## Addendum No. 1

### ITB No. 4510, Watershed Drive Retaining Wall Due: Friday, August 25, 2017, 10:00AM (Local Time)

# Watershed Drive Retaining Wall (ITB No. 4510)

**TYPICAL WALL SECTION**

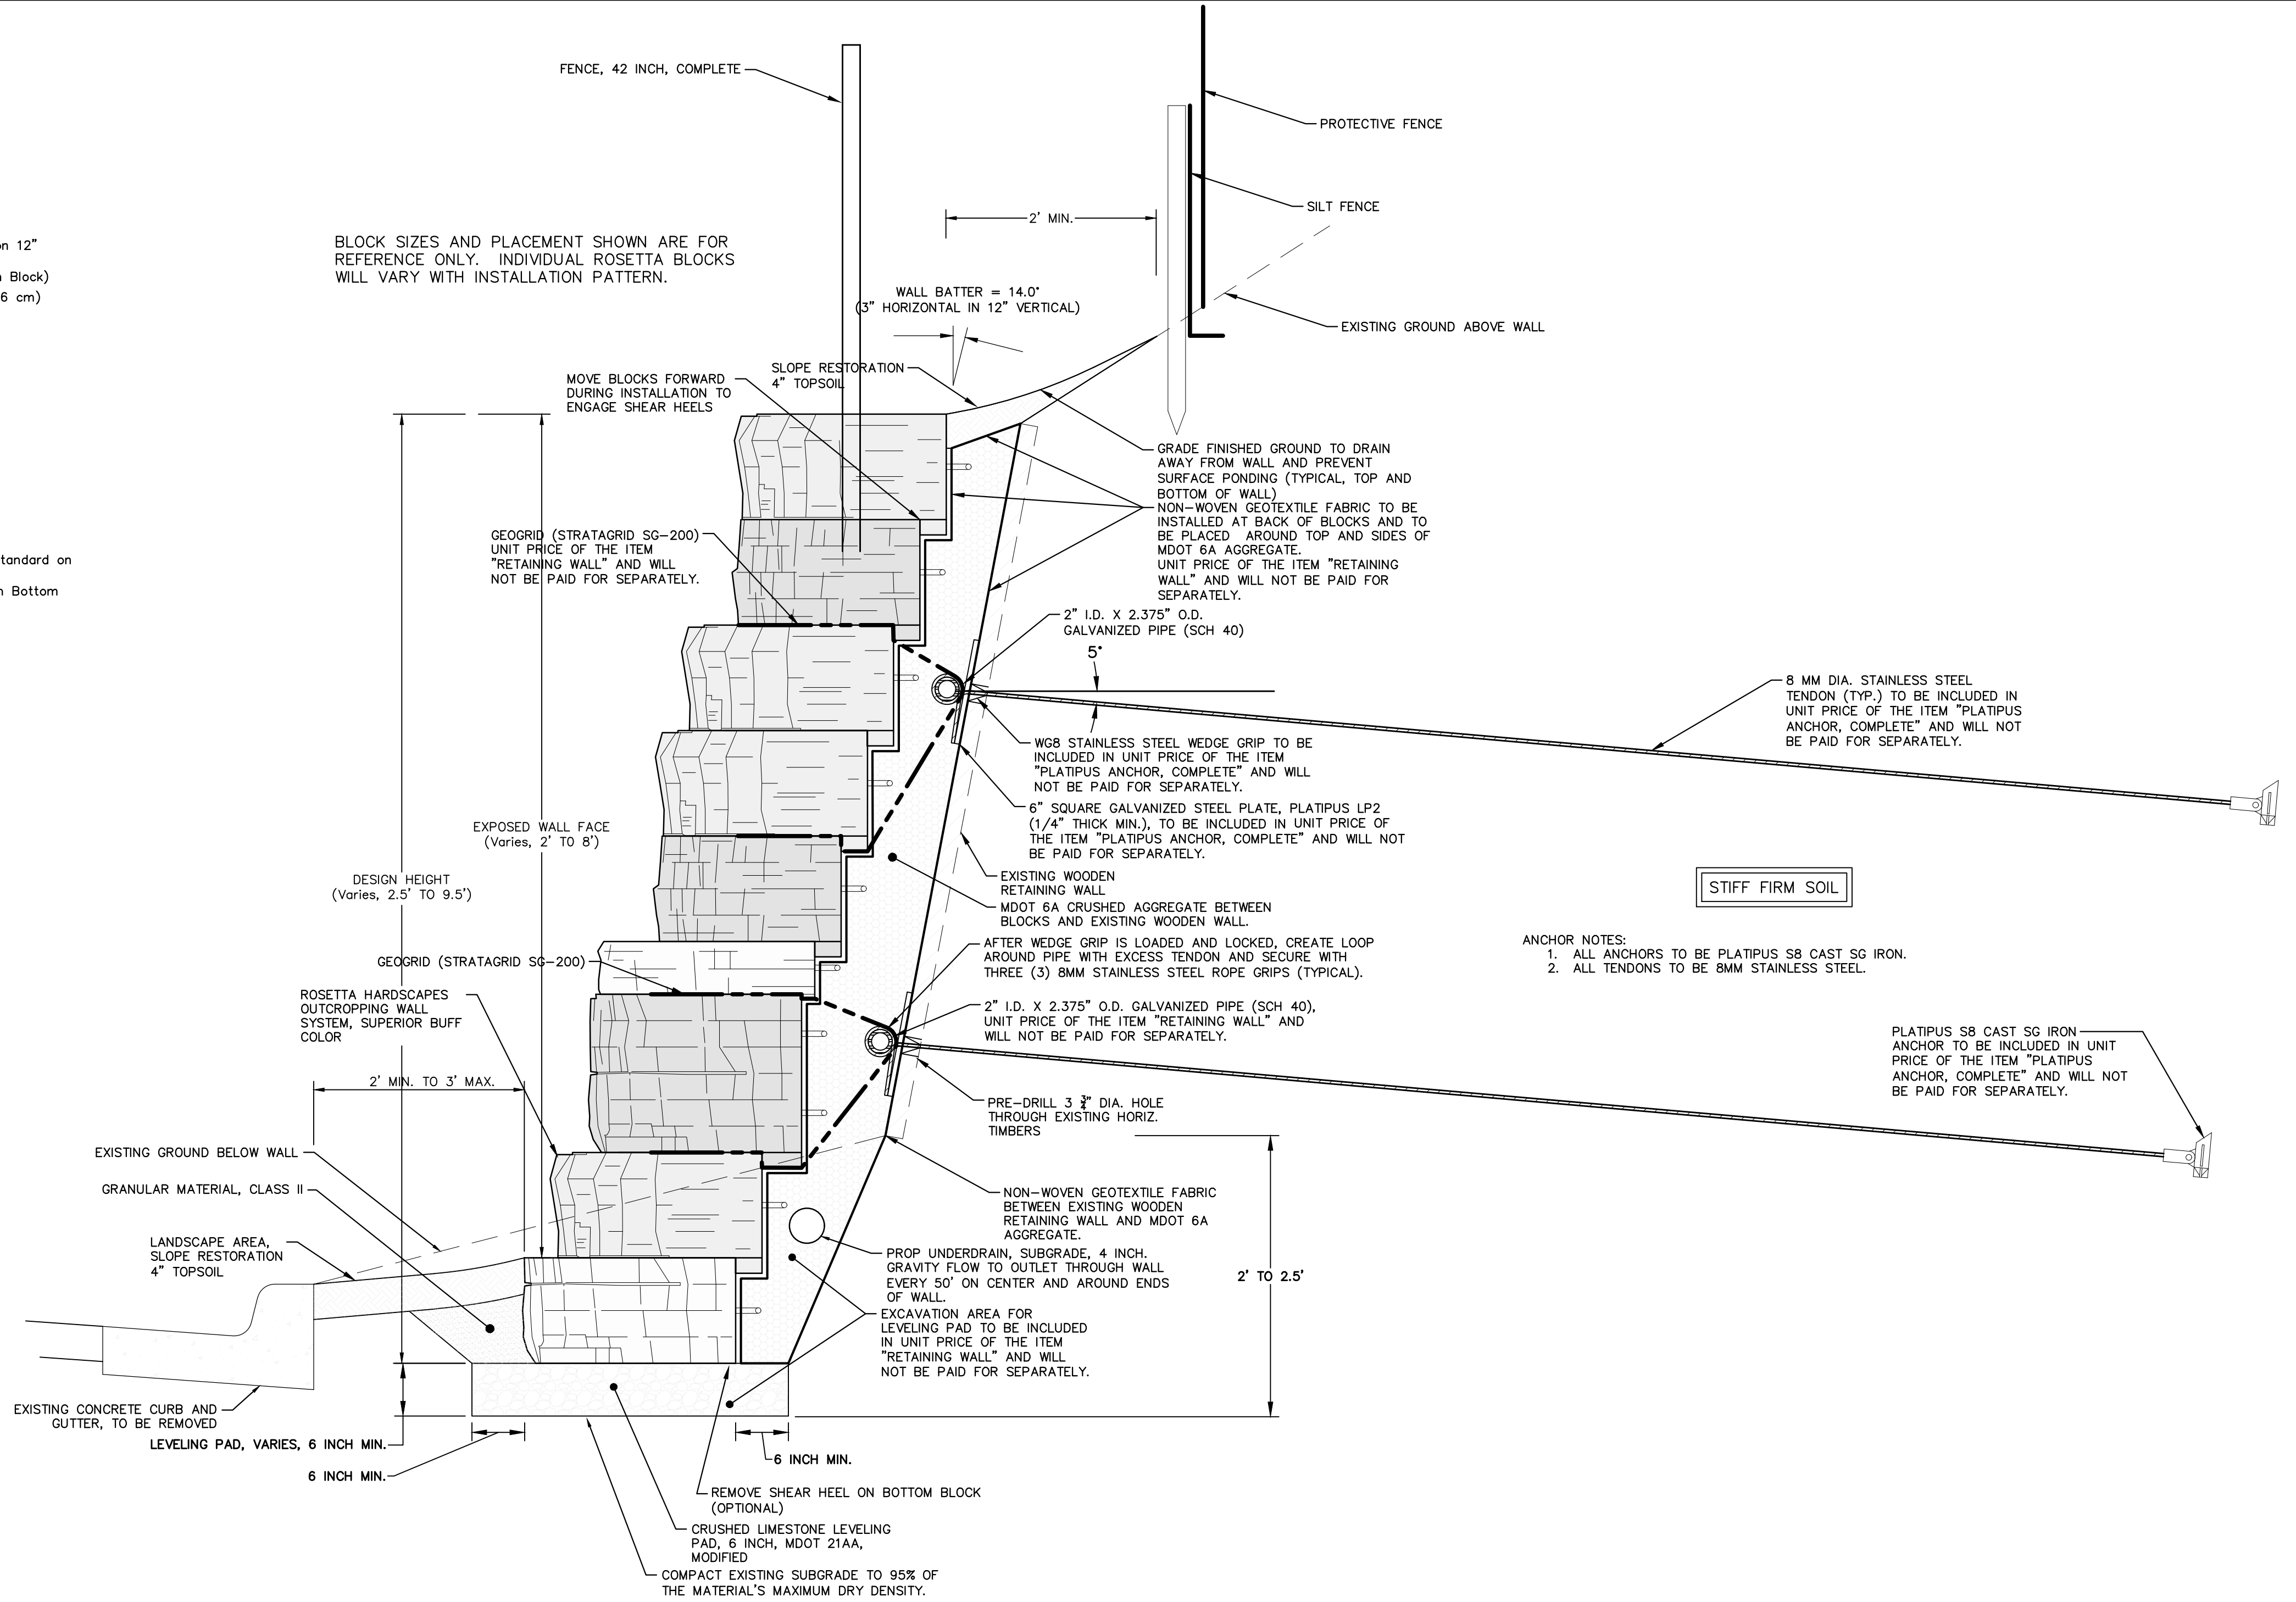
Item #6: Contract Plan Set; replace Bid issued plan set (sheet 4) with that issued for this Addendum 1 (sheet 4).

Changes include the following "Typical Wall Section" detail:

6" SQUARE GALVANIZED STEEL PLATE, PLATIPUS LP2 (1/4" THICK MIN.), TO BE INCLUDED IN UNIT PRICE OF THE ITEM "PLATIPUS ANCHOR, COMPLETE" AND WILL NOT BE PAID FOR SEPARATELY.

AFTER WEDGE GRIP IS LOADED AND LOCKED, CREATE LOOP AROUND PIPE WITH EXCESS TENDON AND SECURE WITH THREE (3) 8MM STAINLESS STEEL ROPE GRIPS (TYPICAL).
